# Technical Bulletin

Model: AT-C1 Booklet Finisher (SR3000) Date: 25-Jul-08 No.: RB7930				
<b>RTB Reissue</b> The items in bold italics have been added.				
Subject: Firmware Release Note: Booklet Finisher	Prepared by: N.Yoshida

Model: AT-C1 Booklet Finisher (SR3000) Date			:e: 15-Jun-	·09	No.: RB793002	
Subject: SR3000 Jam			Prepare	d by: M.	Kumagai	
From: 2nd Tech Support Sec. Service Support Dept.						
Classification:	<ul> <li>☐ Troubleshooting</li> <li>☐ Mechanical</li> <li>☐ Paper path</li> <li>☐ Product Safety</li> </ul>	Part info Electric Transm	al		Servic	n required ce manual revision fit information

Model: AT-C1 Booklet Finisher (SR3000) Date			te: 24-Dec-10		No.: RB793003		
Subject: Parts information			Prepared by: M. Kumagai				
From: 1st Overseas Tech Support Sec., 1st PQM Dept.							
Classification:	fication: Troubleshooting		tion Action required				
	🗌 Mechanical	Electrical			Service manual revisi		
	Paper path			eive	Retrofit information		
	Product Safety	Other (		)	Tier 2

Photo 1 IMPORTANT: Only move the shaft back and forth. Do not rotate.

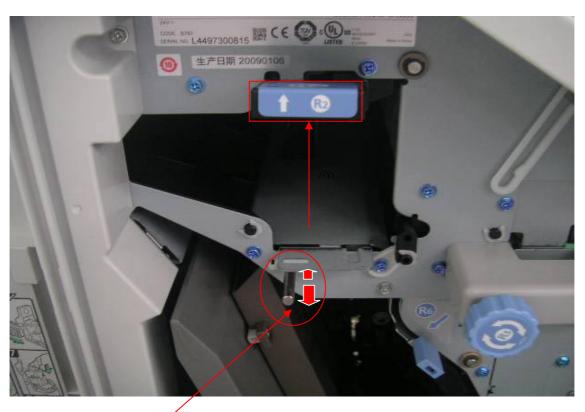
- 1. Open the front cover of the finisher.
- 2. Pull up the "R2" shift guide.
- 3. Move the shift roller shaft (circled in red) back and forth slowly. **Do not** turn the shaft. **Note:** This will cause the shift motor (**B7935817**) to rotate.

Photo 2

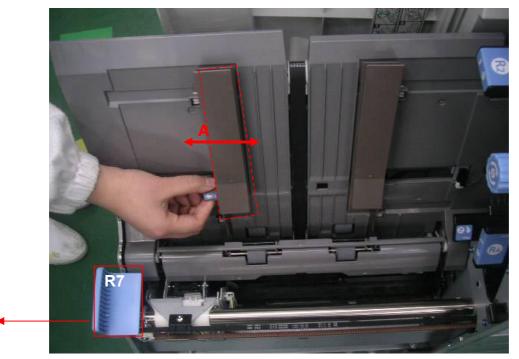
- 4. Pull out the stapler unit using the "R7" guide.
- 5. Move the operator-side jogger fence back and forth slowly three times within the range of movement shown by arrow "A".

Note: This will cause the first B7935815 motor ("Motor 1" in Photo 5) to rotate.

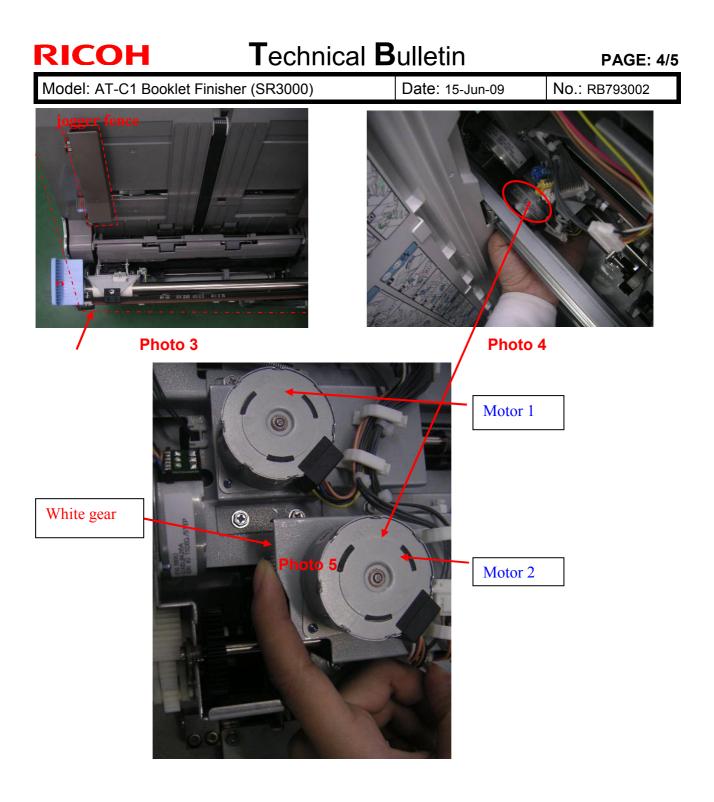
- 6. Confirm the following (See Photo 3):
  - The stapler unit is pulled out as far as it can go
  - The operator-side jogger fence is at its front-most position
- Turn the white gear in Photo 5 clockwise 360 degrees.
   Important: Reach under the rail to access the gear (see Photo 4).
   Note: This will cause the second B7935815 motor ("Motor 2" in Photo 5) to rotate.

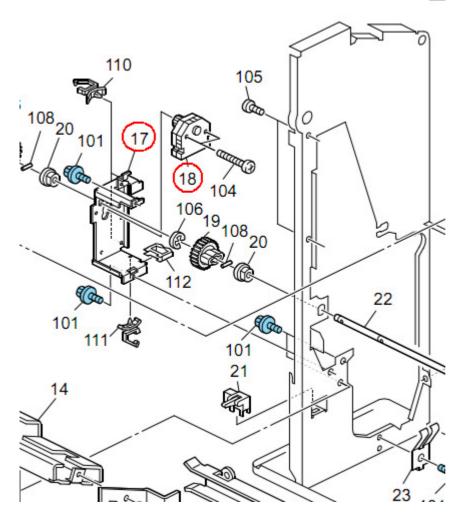
Old part	New part	Description	Q'ty	Int	Page	Index	Note
number	number						
AX040214	AX040248	DC Motor Bracket	1	X/O	30	17	*
B7933111	B7933112	DC Motor: Shift: Upper	1	O/X	30	17	*
		Lower: Drives

These parts have been affected on this cut-in serial #: L4408301002

\*These parts should be replaced as a set.
